**METROPOLITAN GOVERNMENT OF NASHVILLE AND DAVIDSON COUNTY**

**STAFF RECOMMENDATION**  
**1515 Ashwood Avenue**  
**May 16, 2018**

**Application:** Partial Demolition: New construction - addition  
**District:** Belmont-Hillsboro Neighborhood Conservation Zoning Overlay  
**Council District:** 18  
**Map and Parcel Number:** 10416034900  
**Applicant:** Brittney Mount, Allard Ward Architects  
**Project Lead:** Sean Alexander, sean.alexander@nashville.gov

**Description of Project:** The applicant is proposing to demolish the upperstory of an historic house in order to construct a taller upperstory, and to construct a rear addition. The rear addition will be taller than the historic house.

Drawings:  
 Exterior Elevations  
 Date:  
 04.30.18

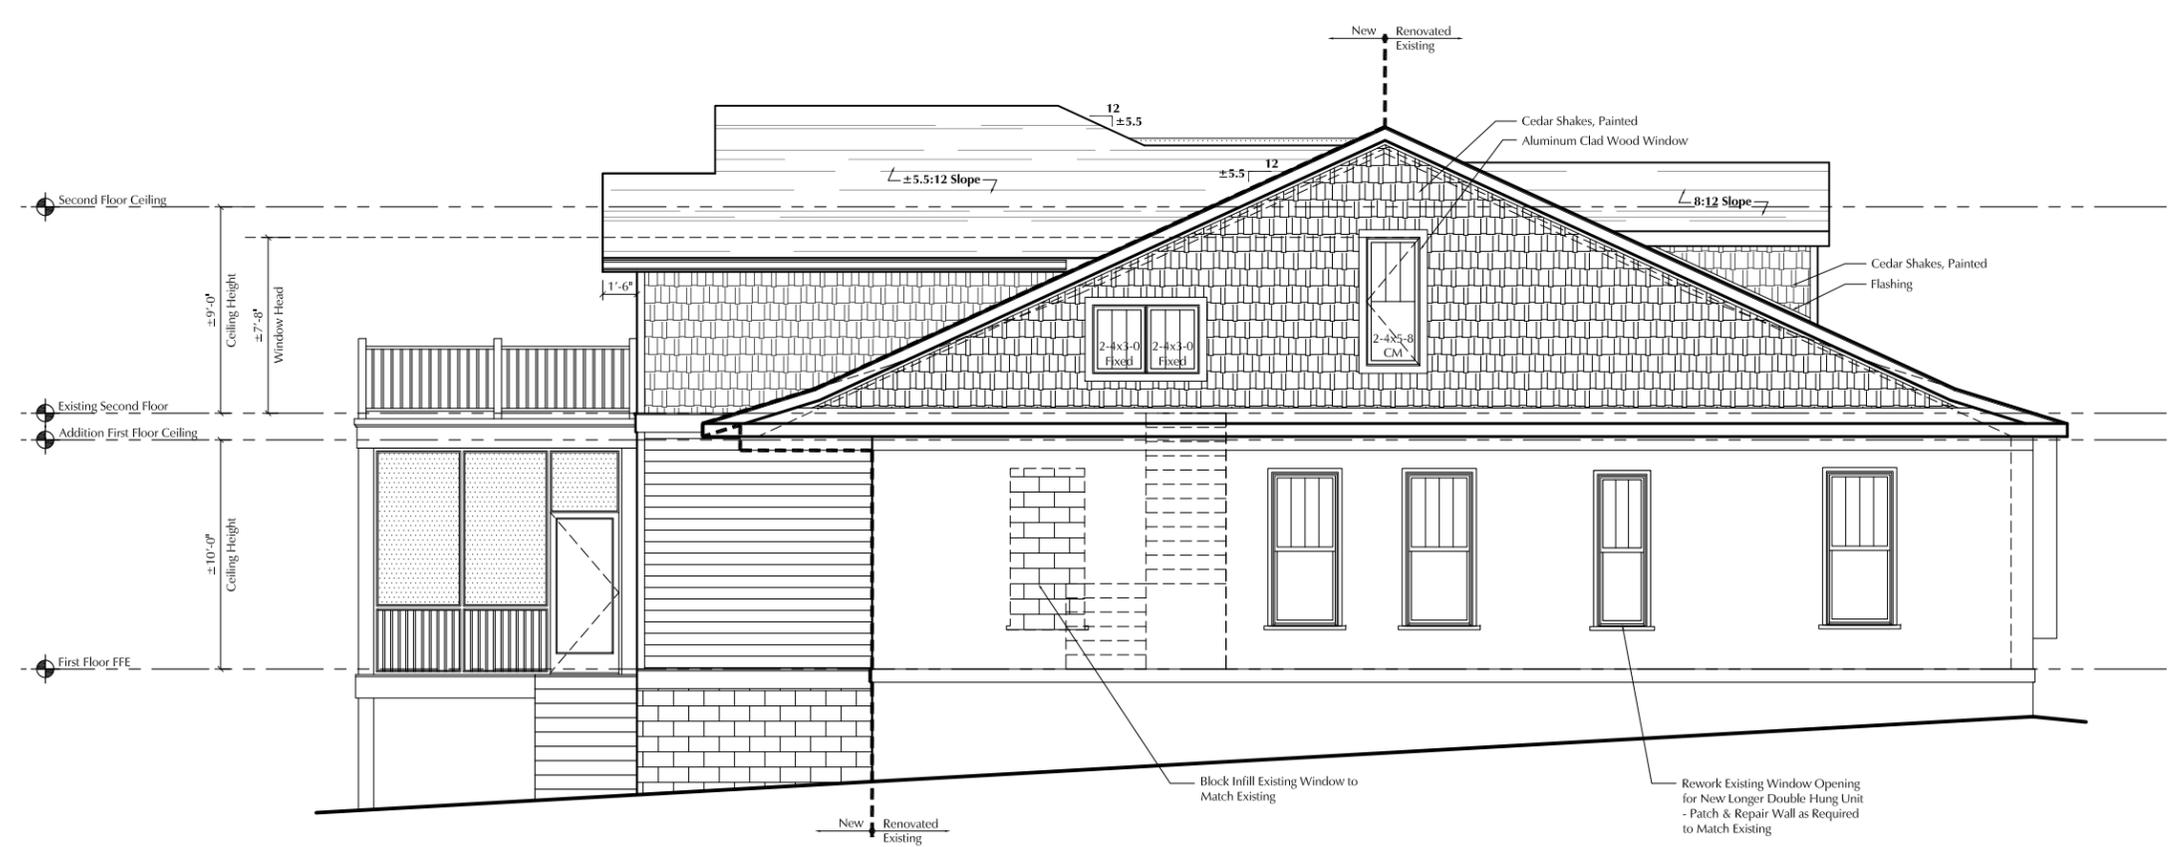
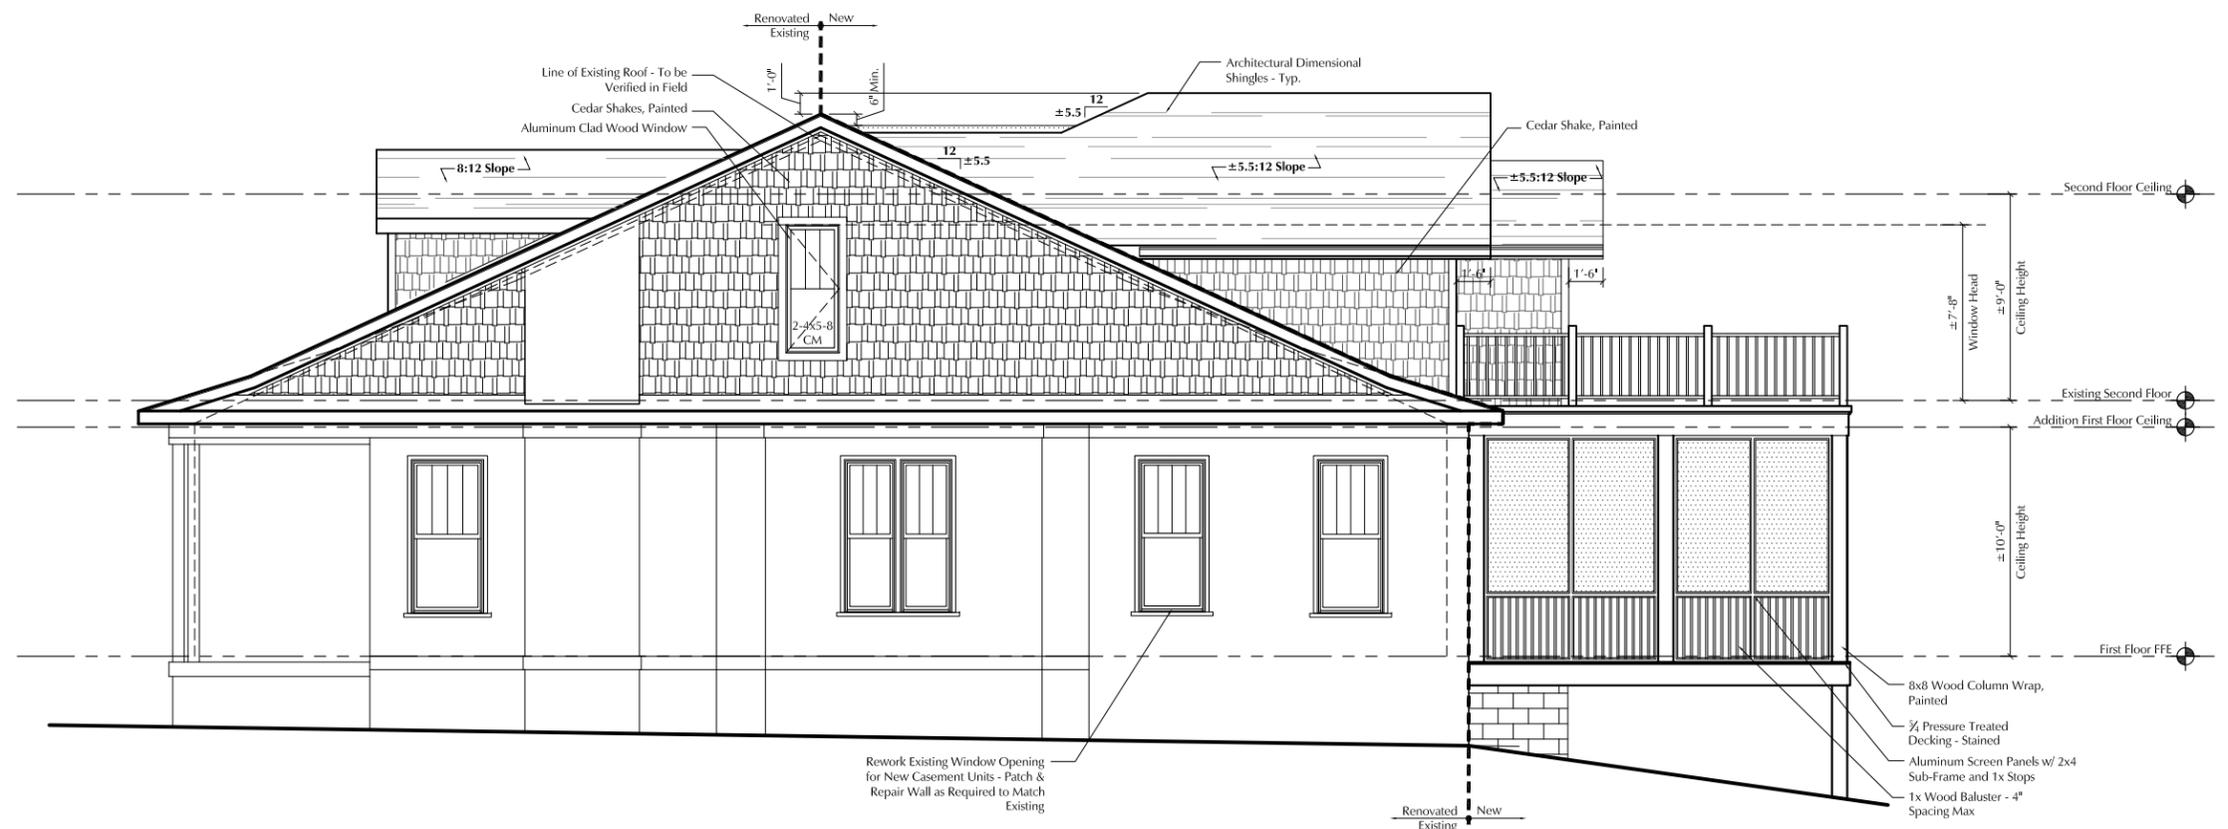
Location & Removability: In removing the existing upperstory and constructing a new one, the height of the building, from floor level to roof peak, would increase from twenty-two feet, six inches (22'-6") tall to twenty-three feet, six inches (23'-6") tall. This change would be an irreversible alteration of the original massing of the house as viewed from the front and sides. Staff finds that this project does not meet sections II.B.2.a and II.B.2.e of the design guidelines.

Height & Scale: As described above, the proposal would increase the height of the existing building by one foot (1'). The rear addition would tie into the rear of the new roof, and extend back with a section of low-sloped roof for eight feet (8'), then extend two feet (2') above the ridge. Because this height would be constructed in conjunction with the demolition of the existing upperstory, the height of the addition would actually be three feet (3') taller than the existing building.

Staff finds that this height is not compatible with the historic house and does not meet Sections II.B.1.a and II.B.1.b of the design guidelines.

Roof form: The roof of the rear addition would consist of a rear-oriented gable with a 5½:12 pitch, with a ridge that would be taller than the historic house. The form and pitch of the proposed roofs could be appropriate, but it cannot be considered independent of the inappropriate demolition. Staff therefore finds that the proposal is not compatible with the historic house and that the project does not meet Section II.B.1.e of the design guidelines.

Proportion and Rhythm of Openings: Alteration of the windows on the existing building have been described in the demolition section previously. The windows on the proposed rear addition are all generally twice as tall as they are wide, which is typical of the historic proportions of openings. There are would be no large expanses of wall space on the addition without a window or door opening. Staff finds the addition’s proportion and rhythm of openings would meet Section II.B.1.g of the design guidelines.
